AGENDA

PLANNING AND ZONING COMMISSION WORK SESSION City Hall, 385 South Goliad, Rockwall, Texas Council Chambers May 28, 2019 6:00 P.M.

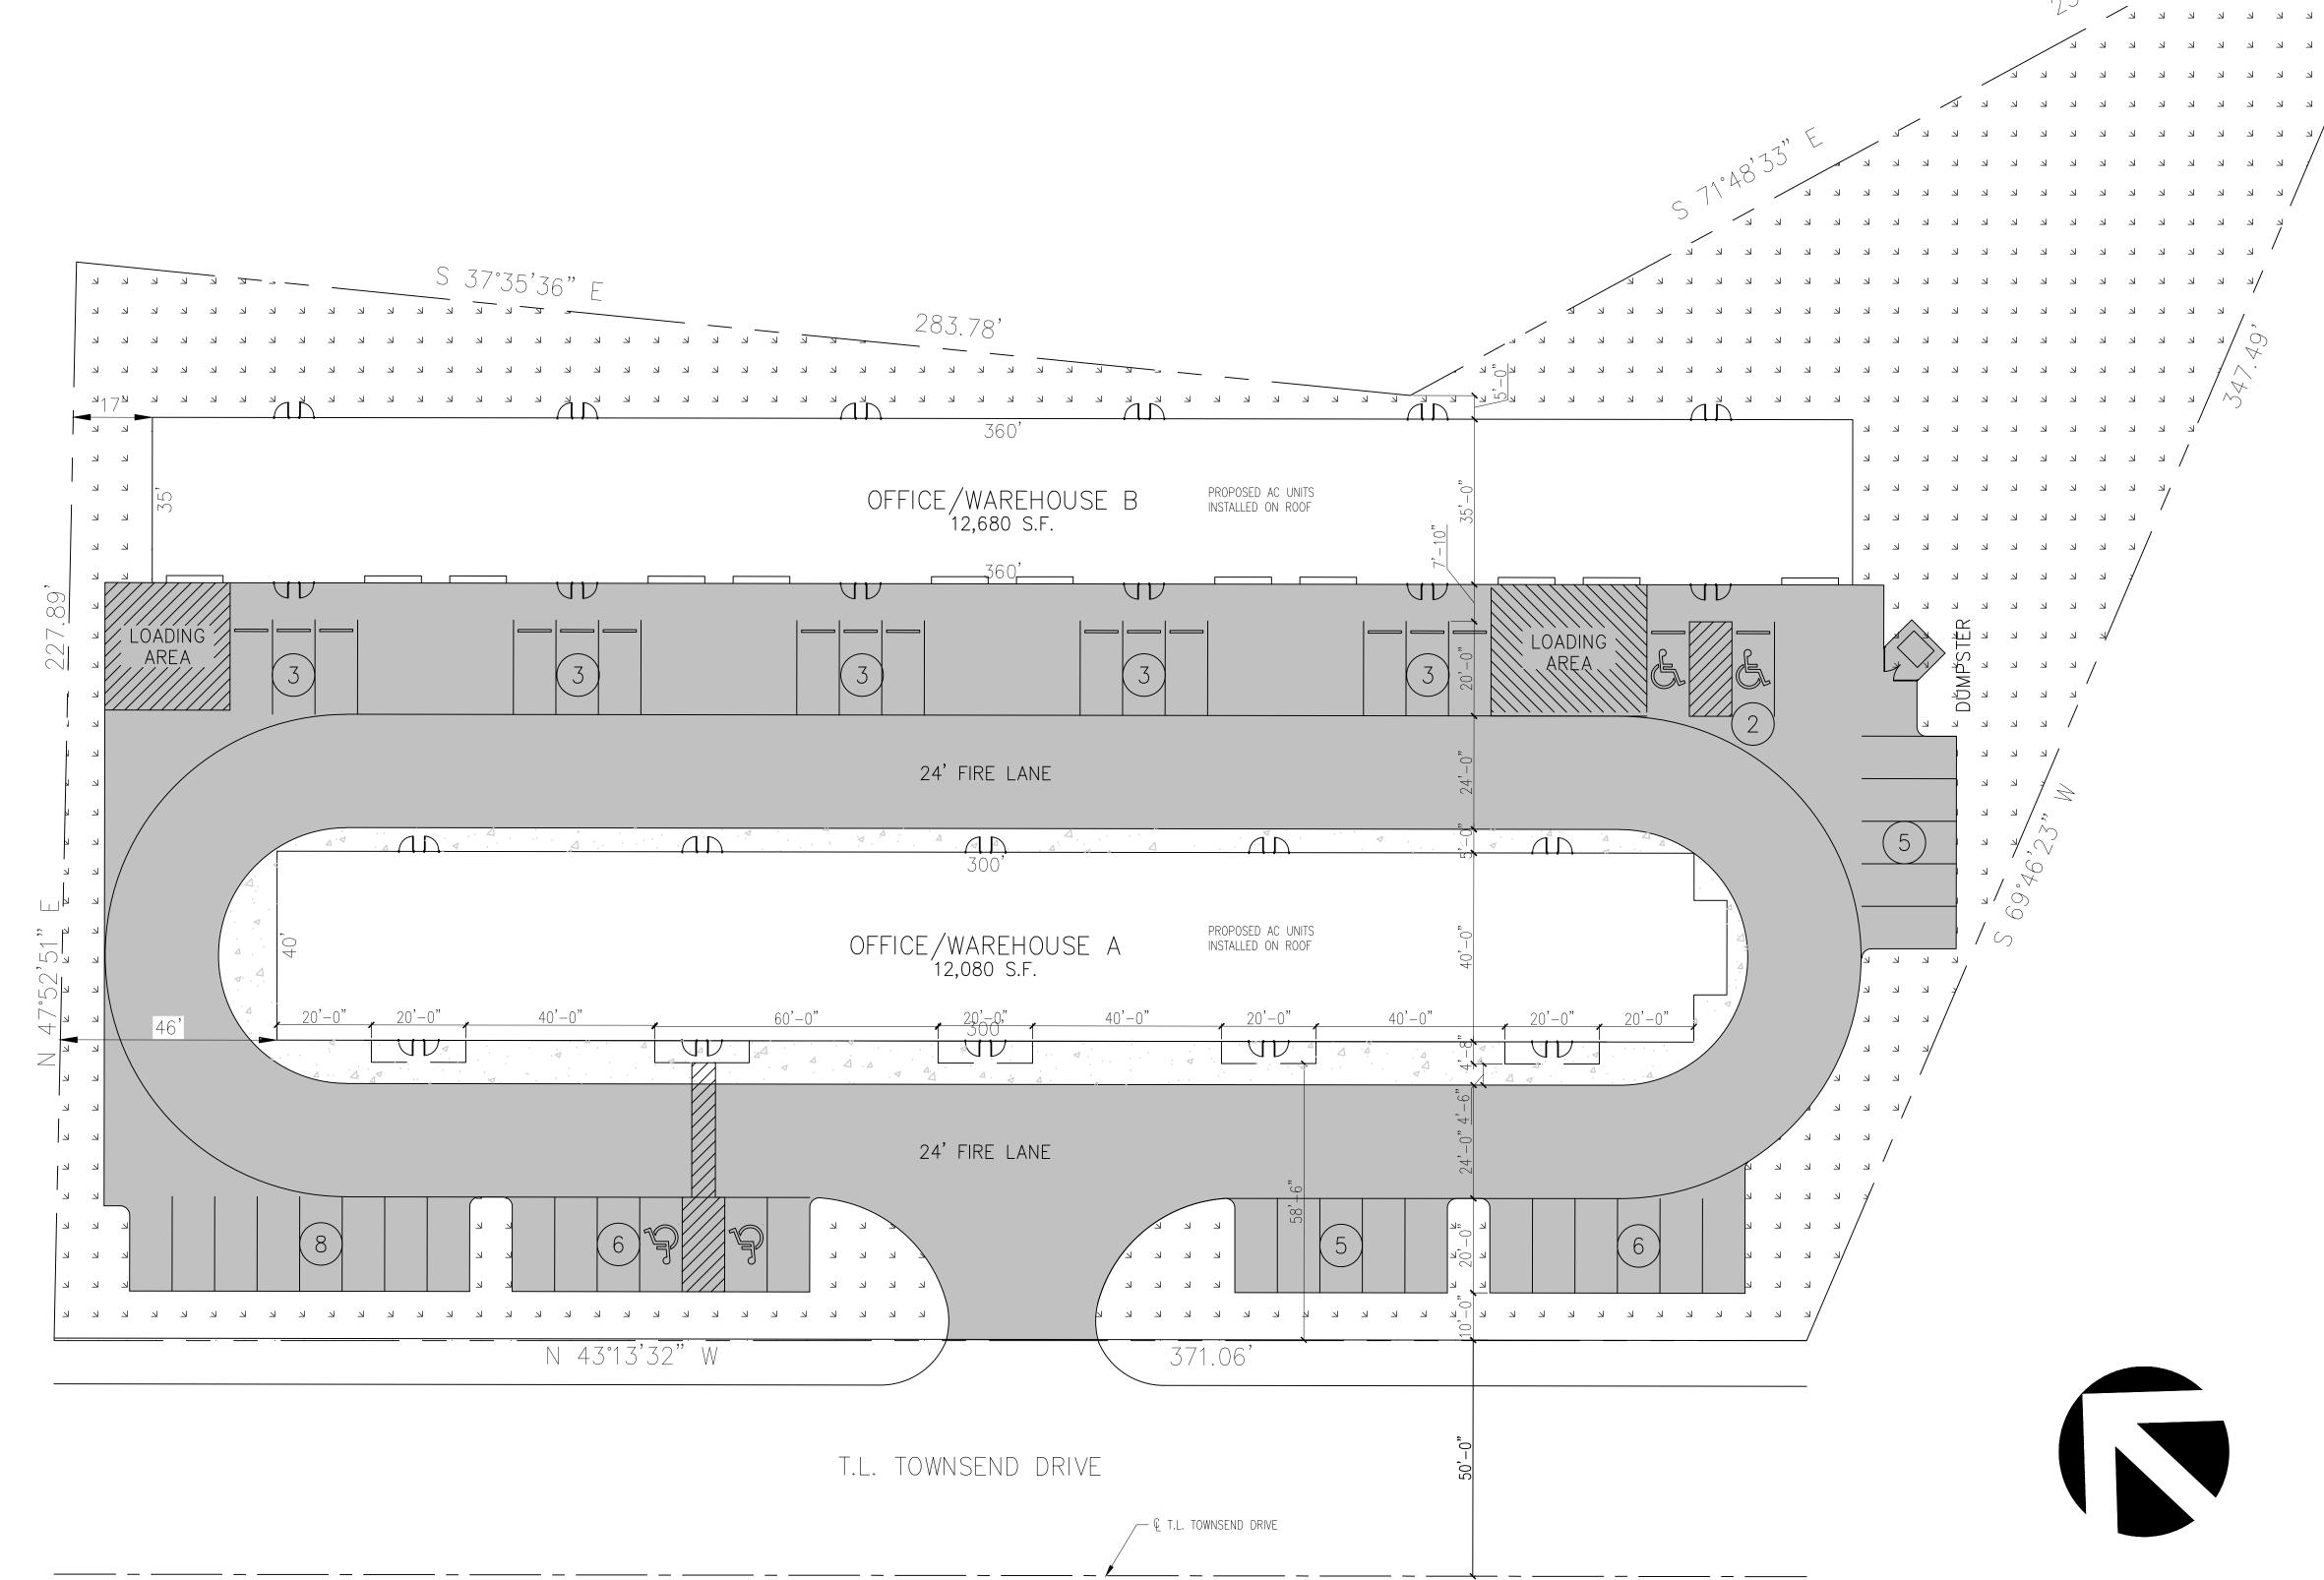
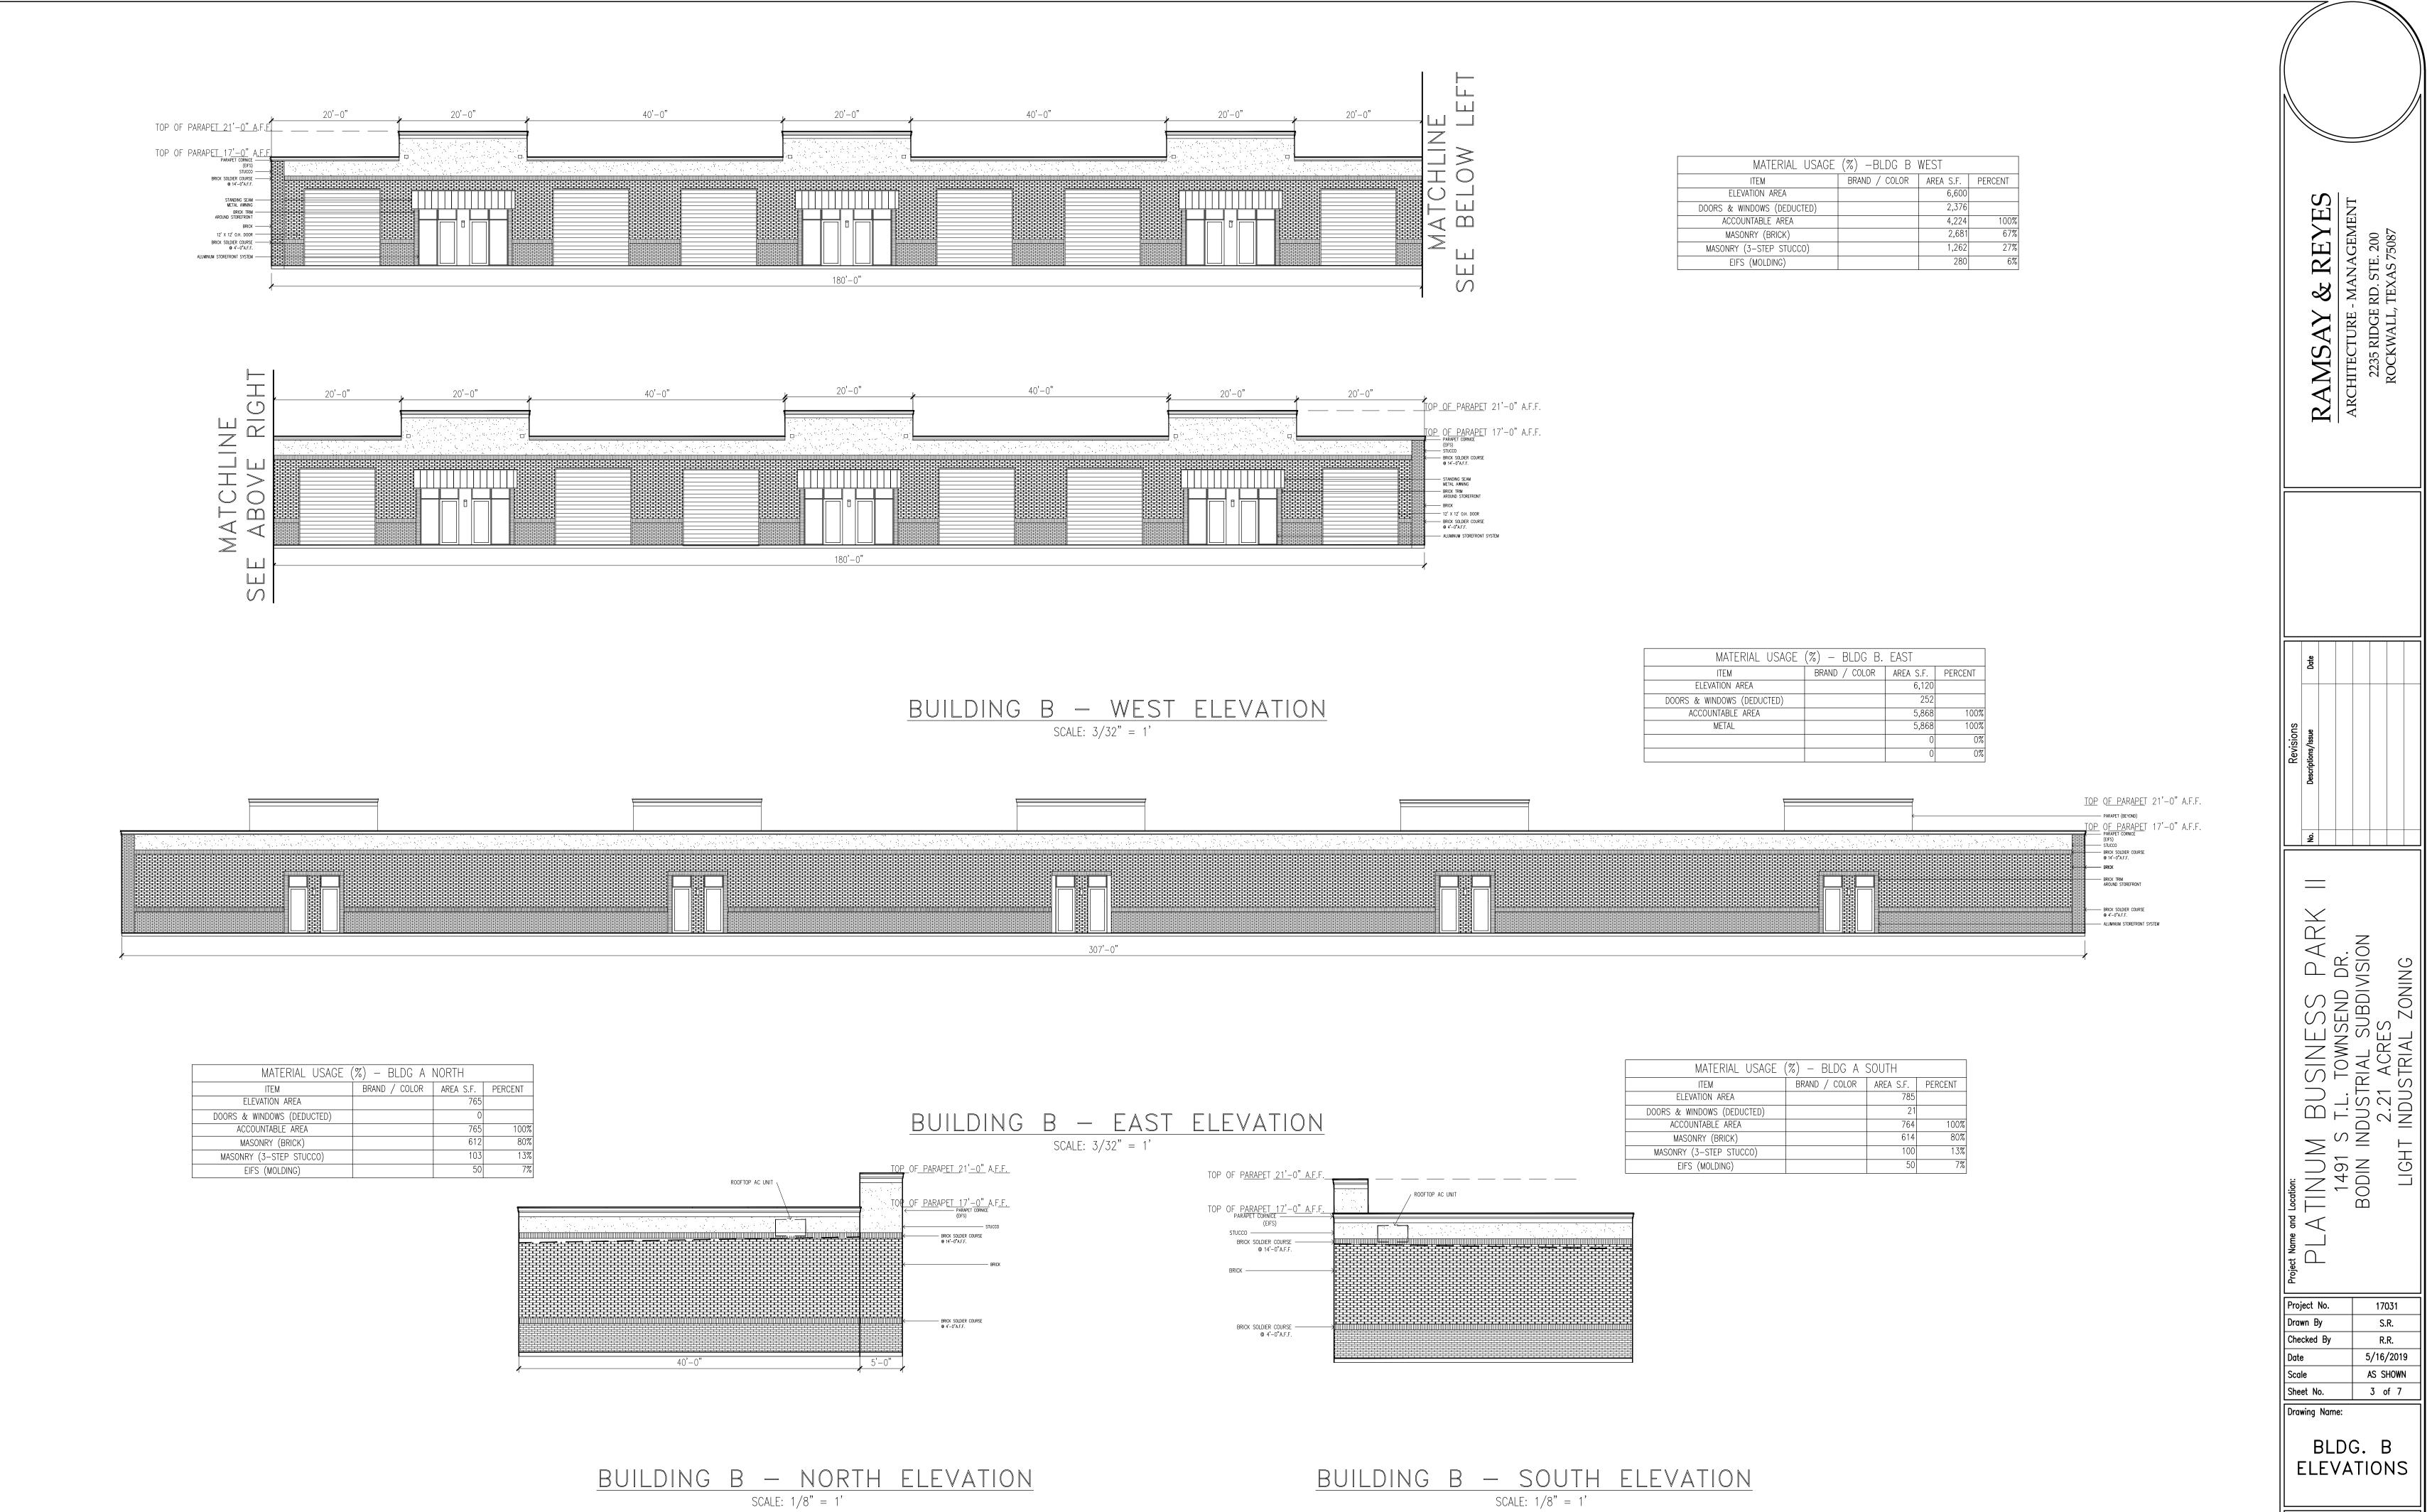
- 3. For reference, include the case number (SP2019-018) in the lower right hand corner of all pages on future submittals.
- 4. Sheet S-1—Please add the following to the site data table: pervious vs. impervious area and %, req. parking, office SF, warehouse SF.

- 5. Sheet S-1—Please add engineering information (e.g. all easements, radii, topo, etc) graphic scale, vicinity map.
- 6. Sheet S-1—Please label property line.

- 7. Sheet S-1---Please show full extend of T.L. Townsend and label centerline.
- 8. Sheet S-1—What is the hatch pattern covering the site? Please remove

- 9. Sheet S-1—Please show fireline and one shade of grey and non-firelane/sidewalks as a lighter shade.
- 10. Sheet S-1—Please show all sidewalks
- 11. Sheet S-1—Please provide paving material and depth.

- 12. Sheet S-1--what is the hatch pattern closest to the buildings?
- 13. Sheet S-1—Please show all building setbacks and landscape buffers.
- 14. Sheet S-1—Please show adjacent properties and provide property information.

- 15. Sheet S-1—Please note that as drawn, this will need variances to horizontal articulation.
- 16. Sheet S-1—Please note that Building B appears to be too close to the property line. Please provide dimension from building to all property lines.

- 17. Sheet S-1—Please note that parking spaces are 9x20. Please dimension a typical parking space.
- 18. Sheet S-1—Please label the space between each group of parking spaces.

- 19. Sheet S-1—What are the "L" shape lines next to each of the doors on Building A?
- 20. Sheet S-1—Please note that no parking space shall be more than 80-feet from a large tree.

- 21. Sheet S-1—Please provide owner/engineer/developer information on site plan.
- 22. Sheet S-1—Please note that the dumpster enclosure shall be 6-feet in height and constructed of materials matching main structure with opaque self-latching gate. Please add note to plans.

- 23. Sheet S-1—Please note that all plans need to be prepared by a registered architect, engineer, or landscape architect. There does not appear to be any engineer/architect seal on the site plan.
